Subj: TRANSMITTAL OF THE ADMINISTRATIVE MEMORANDUM, CHANGES TO
REMOVAL ACTION AT SITE 15, NAVAL AIR STATION (NAS), ALAMEDA, CA

**ADMINISTRATIVE MEMORANDUM
CHANGES TO REMOVAL ACTION AT SITE 15
NAVAL AIR STATION ALAMEDA**

25 October 1995

FIGURE 2: Site Layout of the Temporary Storage and Treatment Area (TSTA)

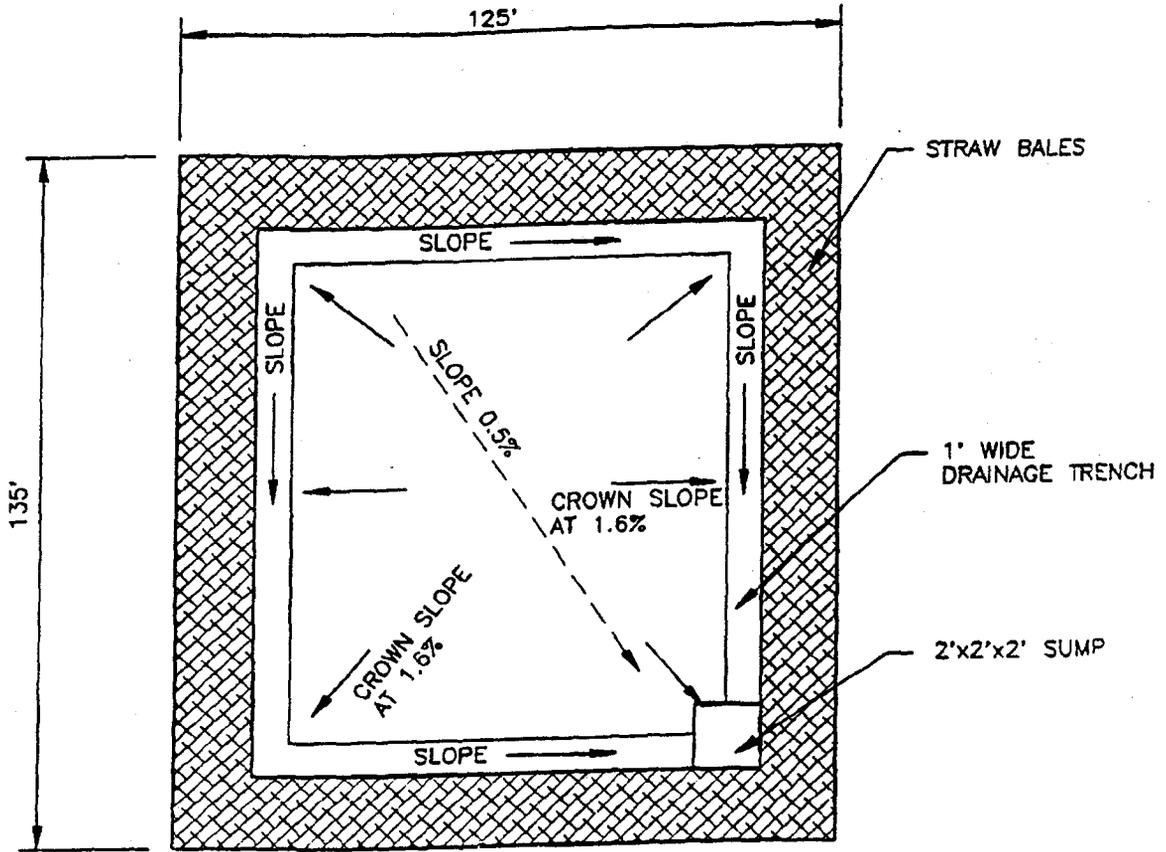
Figure 2 shows the site layout of the TSTA. The TSTA will consist of a bermed containment unit, lined and covered with liner material, with a sump and temporary tank for collection of any water runoff, in the unlikely event the cover liner might fail (accidentally ripped, torn or blown off). The bermed containment unit will be approximately 17,000 square feet in area, with a maximum design capacity of 7,000 cubic yards of soil. The base of the containment unit will consist of perimeter berms constructed from hay bales or similar material, with the entire containment unit covered with 2 layers of synthetic liner material, as shown on Figure 3. After the soil has been placed within the berms, it will be covered with the same type of liner and weighted down with sand bags within the bermed perimeter. An impermeable landfill cover will then be placed over the entire unit, anchored along the outside perimeter of the berm.

Figure 3:
Plan and Cross Section View of the
Temporary Storage and Treatment Area
(TSTA)

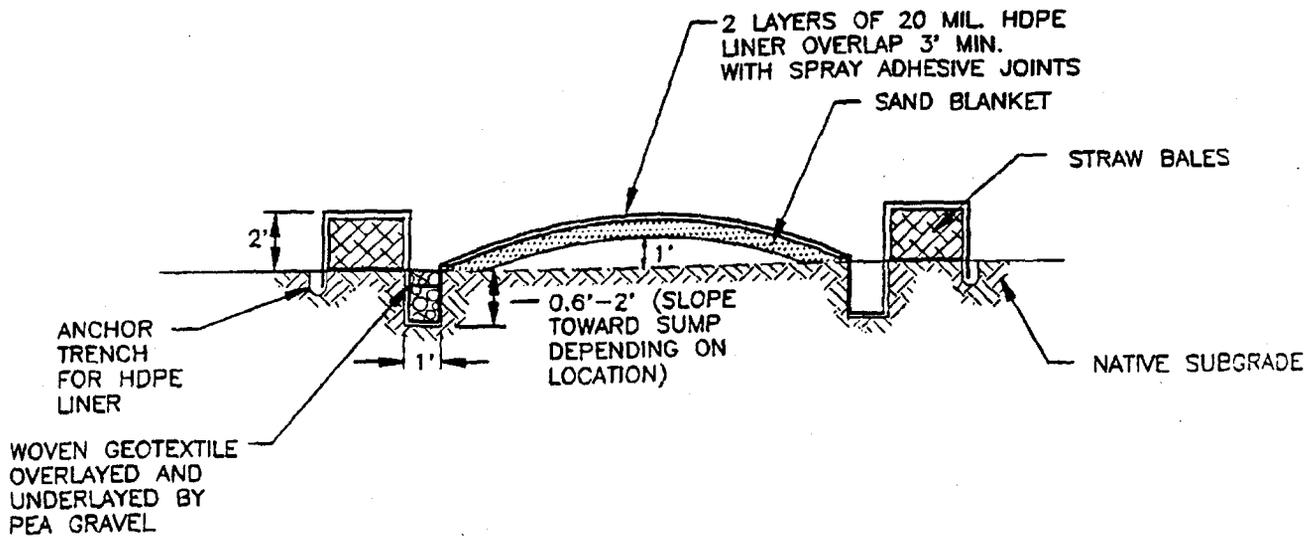
The interior of the containment unit will have perimeter drainage trenches filled with pea gravel and covered with woven geotextile material. The drainage trenches will be located just inside the straw bales and will be sloped toward the sump (Figure 3). The interior of the area will be graded to create a crown in the center approximately one foot above existing grade. The crown will be sloped to the perimeter drainage trenches in all directions. This will promote positive drainage toward the sump. The sump will be constructed at that corner of the containment unit. An ancillary tank will be located nearby to provide temporary storage of any water runoff.
